Addendum 2
Request for Quotation
MA26-5368 Elevator and Accessible Washroom
Renovation at Burnhamthorpe PS

PROJECT NO. 26105
HOSSACK ARCHITECTURE

ADDENDUM NO. 2

Issued by email June 23, 2026

HVAC - PARTIAL PLANS - NEW WORK

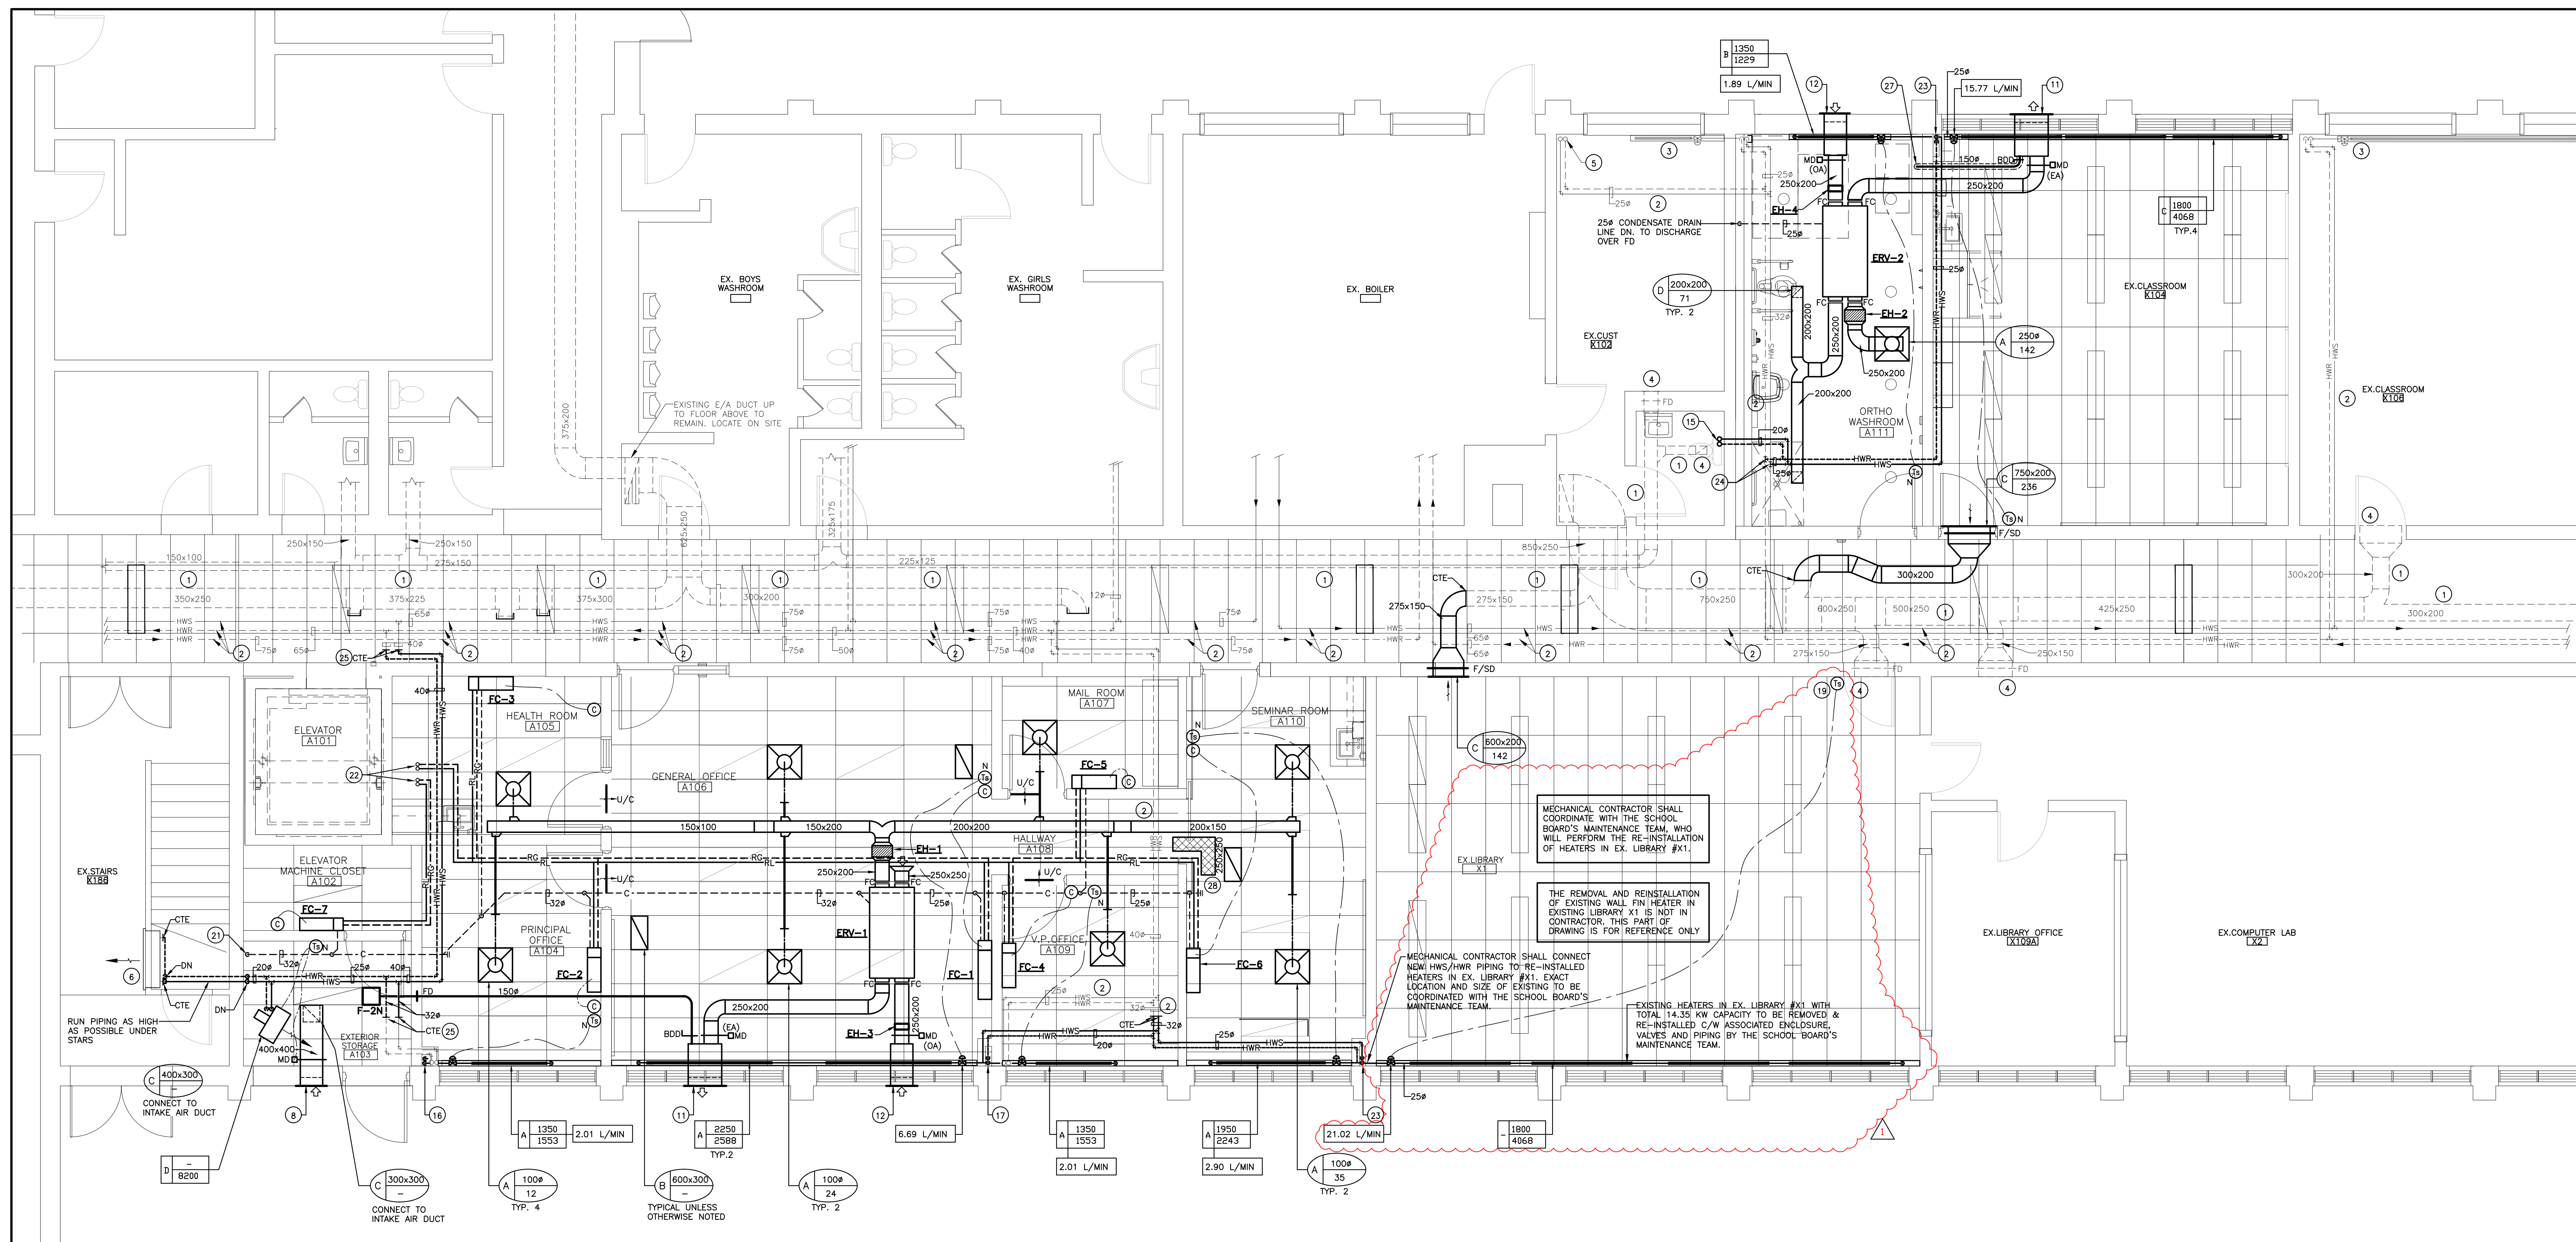
1. Drawing M1 and M2 (Drawings Issued)

- 1 EX. LIBRARY #X1: Delete the scope of work in Ex. Library #X1 as shown on the drawings.

3 SCHEMATIC DETAIL OF ELEVATOR SUMP PIT AND PUMP N.T.S.

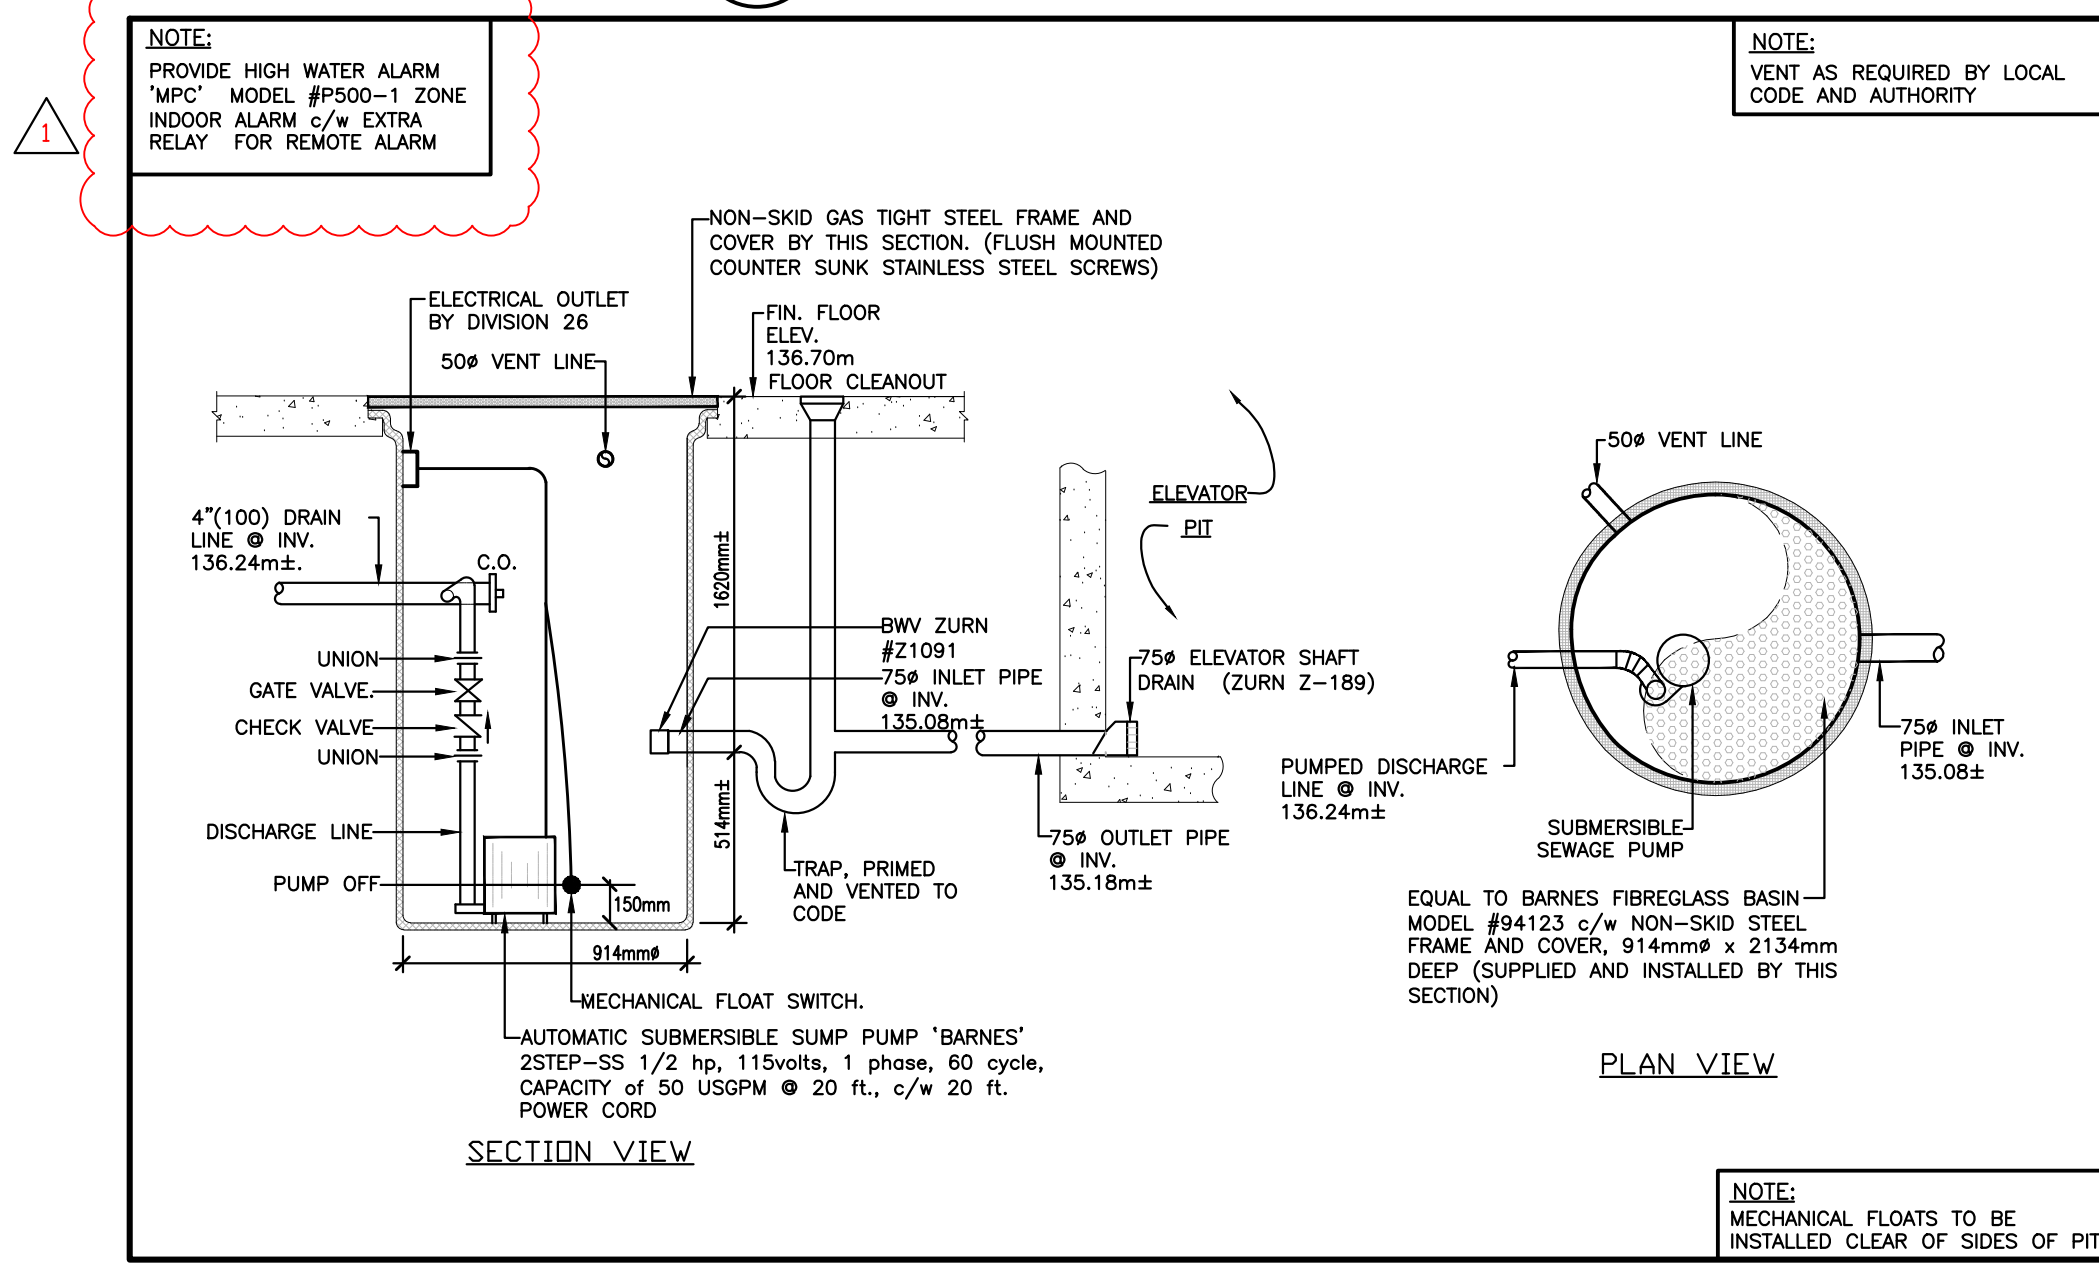
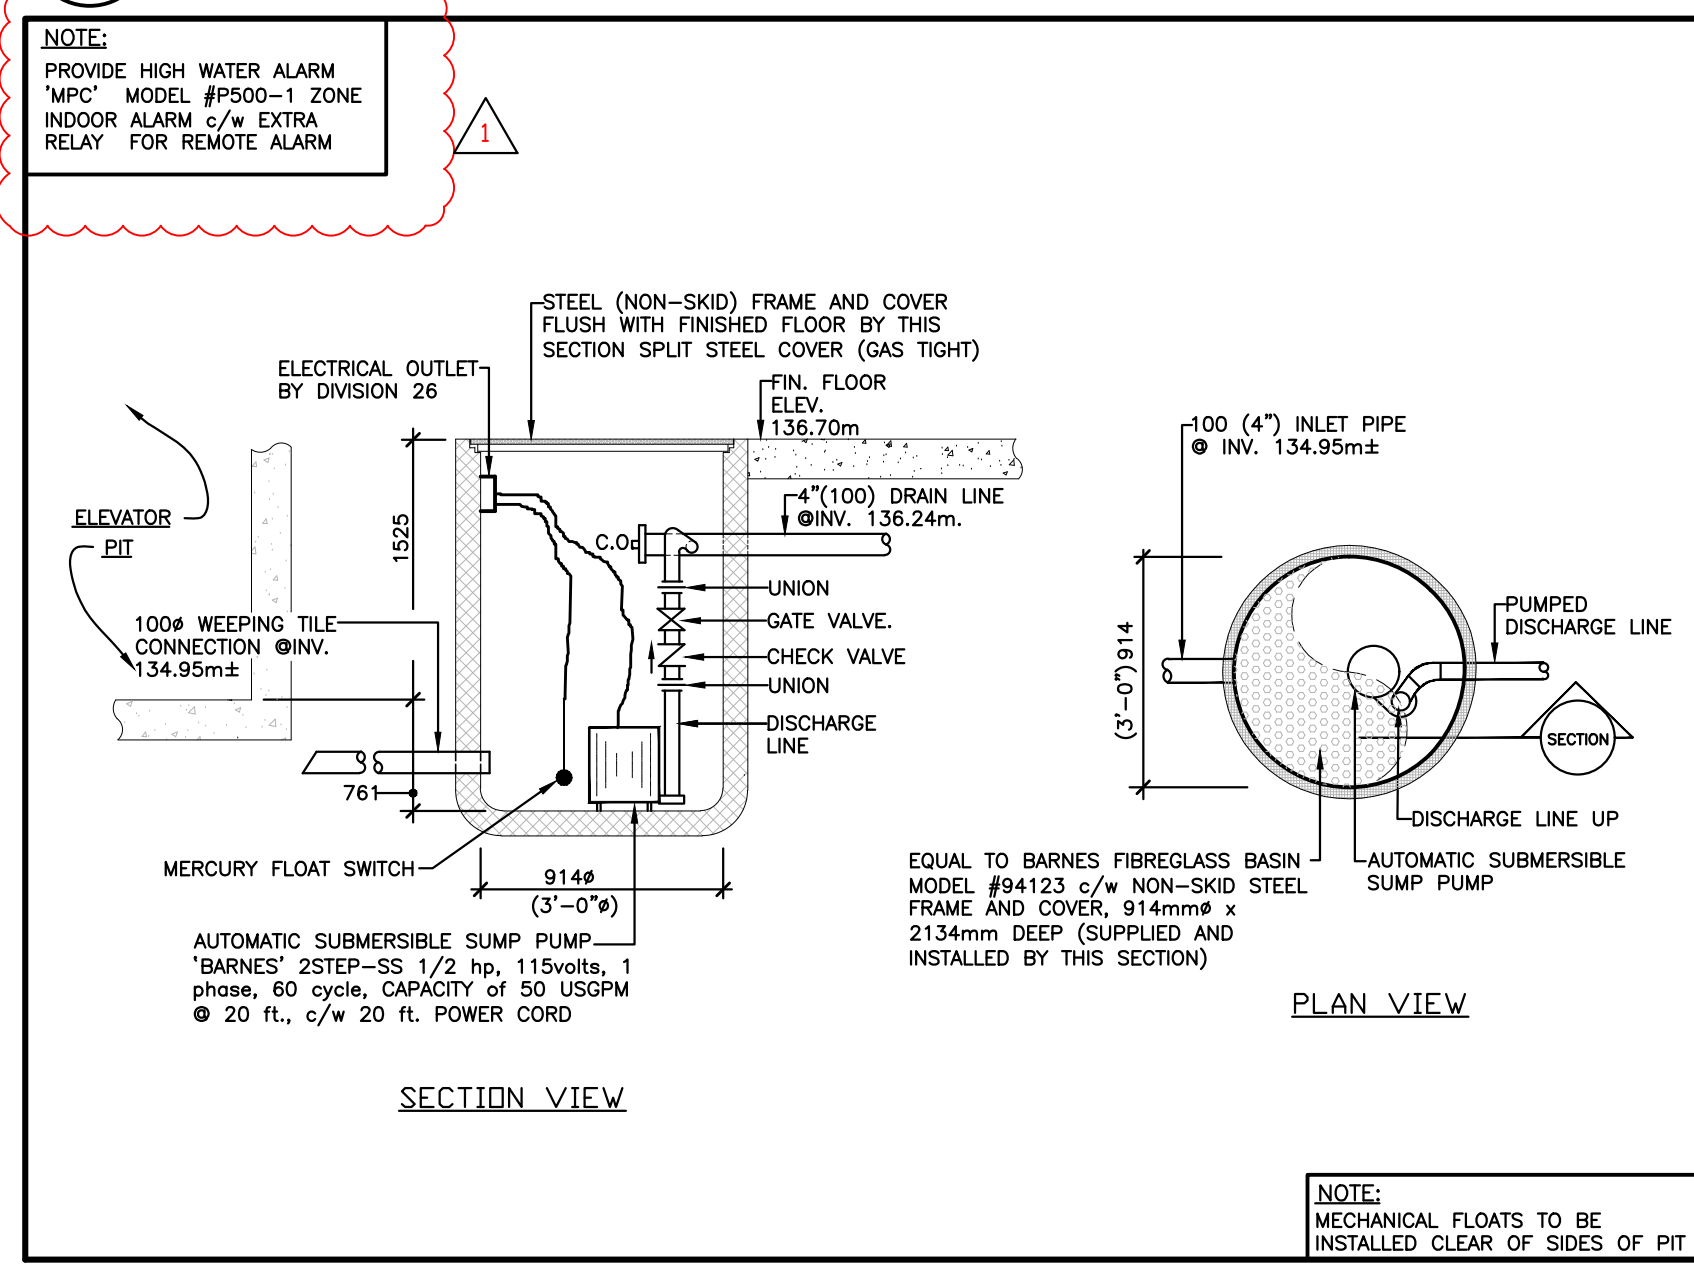
4. Drawing PD3 (Drawings Issued)

- 1 Revise the model number for high water alarm panels as shown on the drawing 3/PD3 and 4/PD3.

DRAWING TITLE:
DOOR OPERATOR, PUSH BUTTONS, AND ANNUNCIATOR PANEL INSTALLATION DETAILS

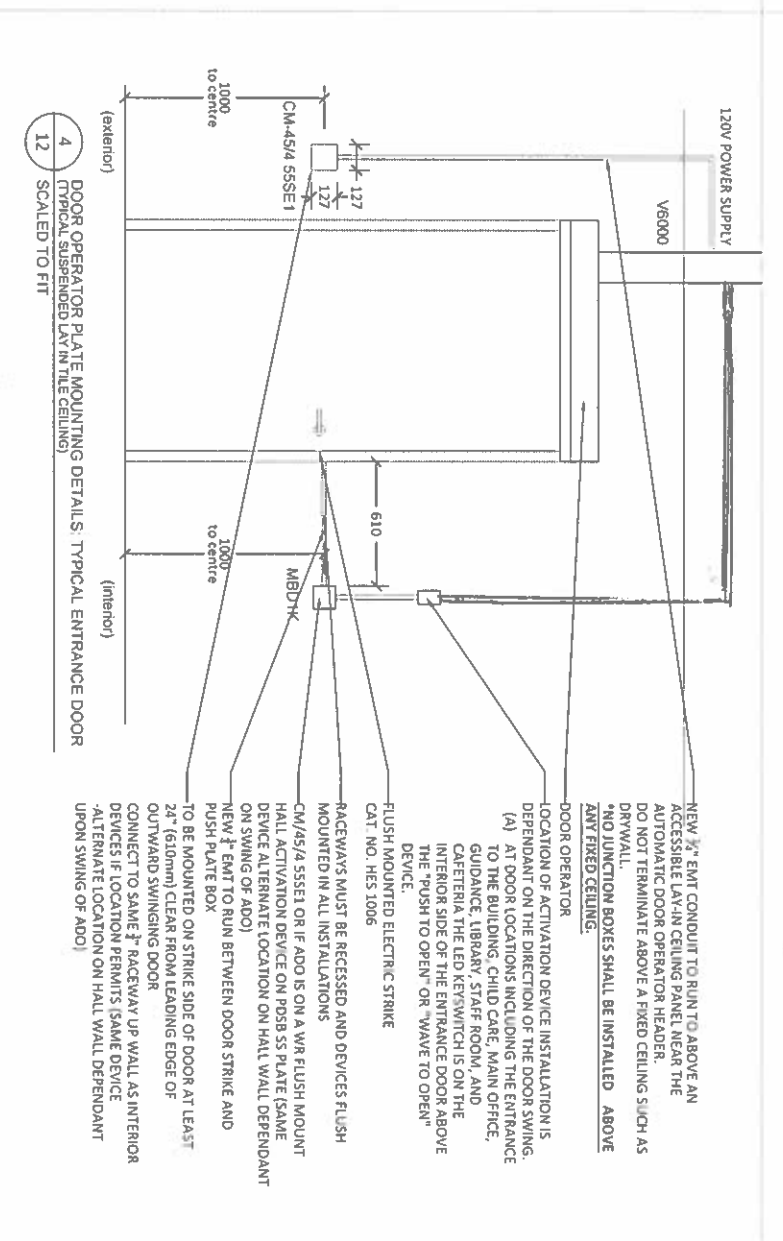
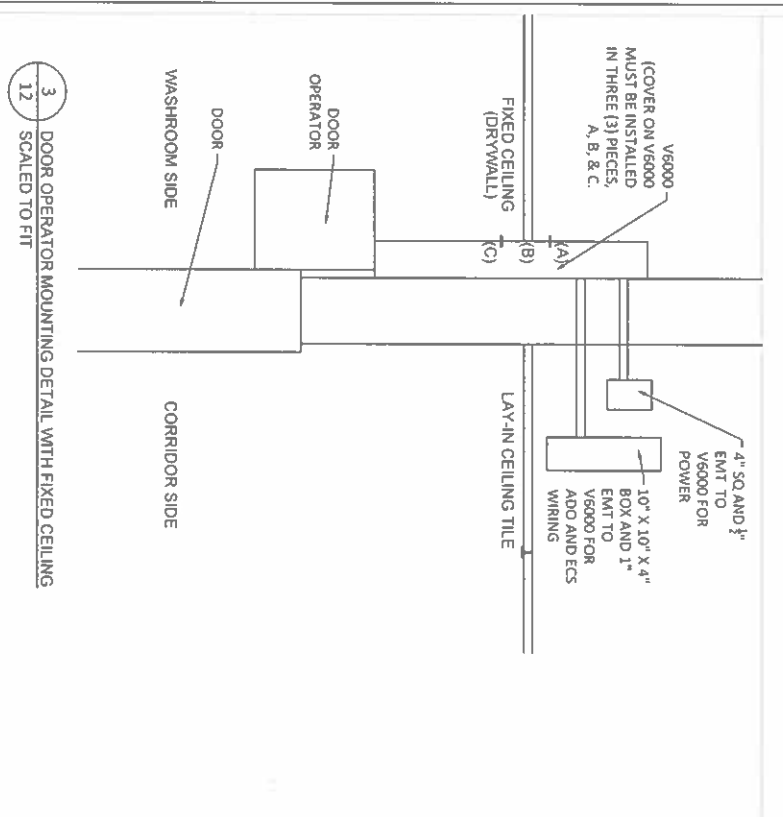
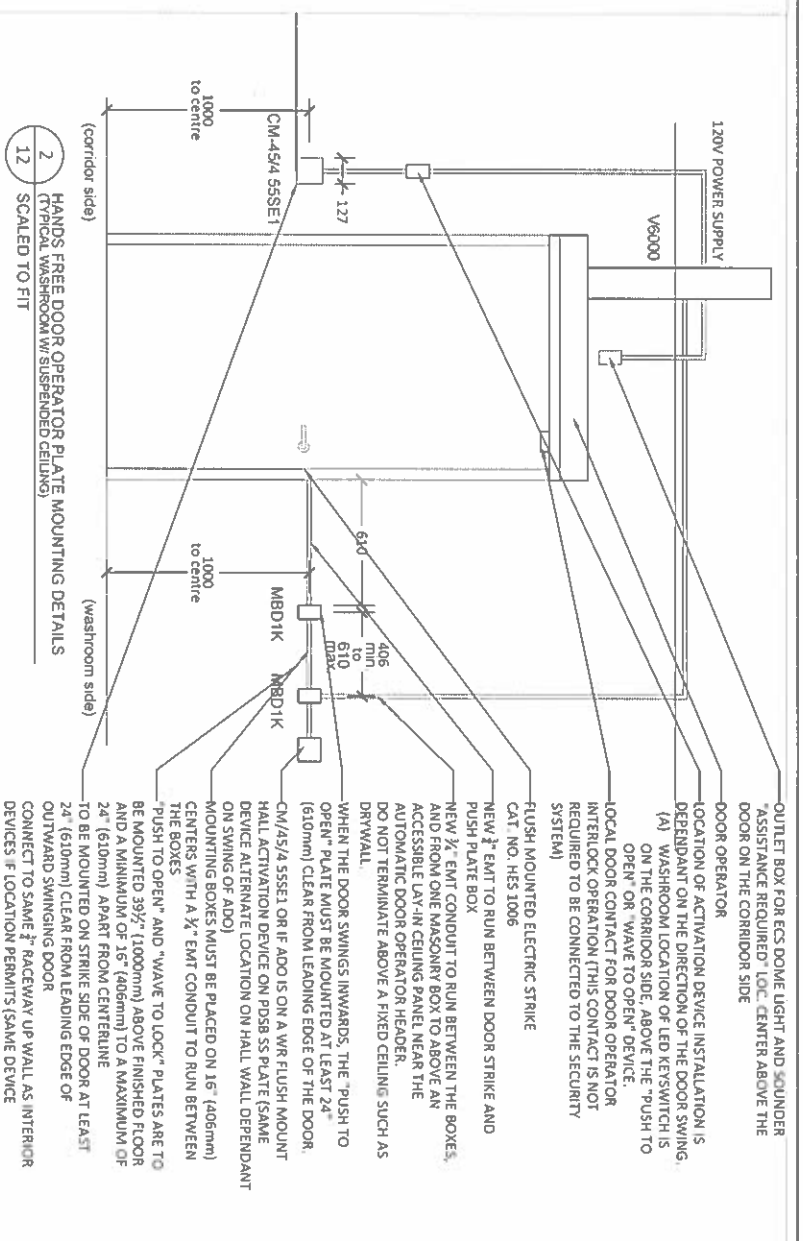
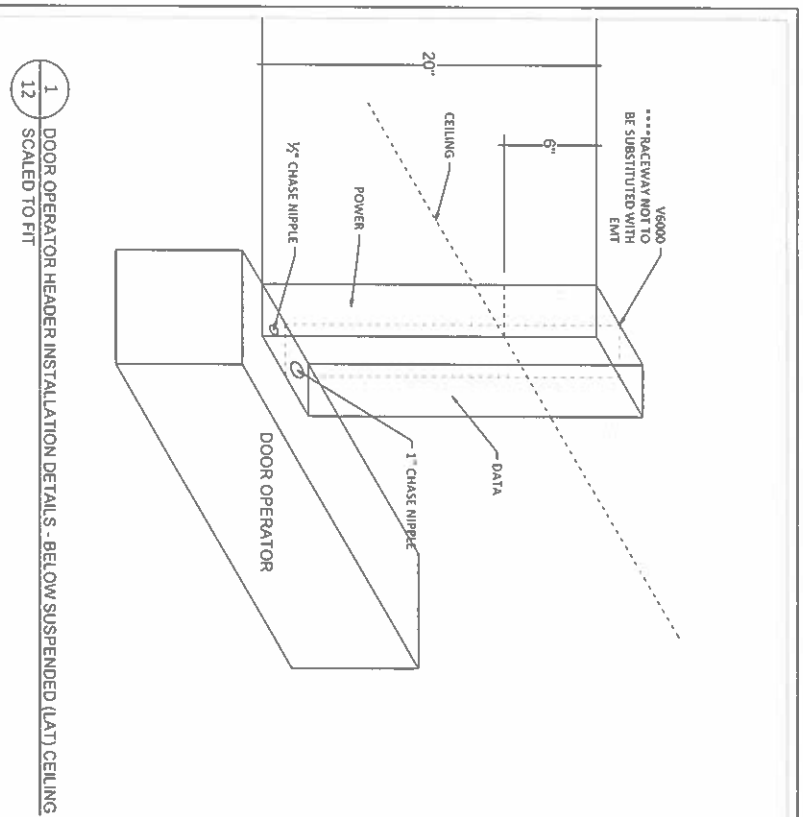
5. Coordinate location, installation, mounting height with attached PDSB installation detail. Coordinate exact location with Owner before rough-ins.
6. **Drawing E3 (Sketches issued)**

- 6.1 Detail #4, Coordinate installation of BF Washroom and Office Annunciator installation with the attached sketches.
7. **Drawing E8 (Drawing issued)**
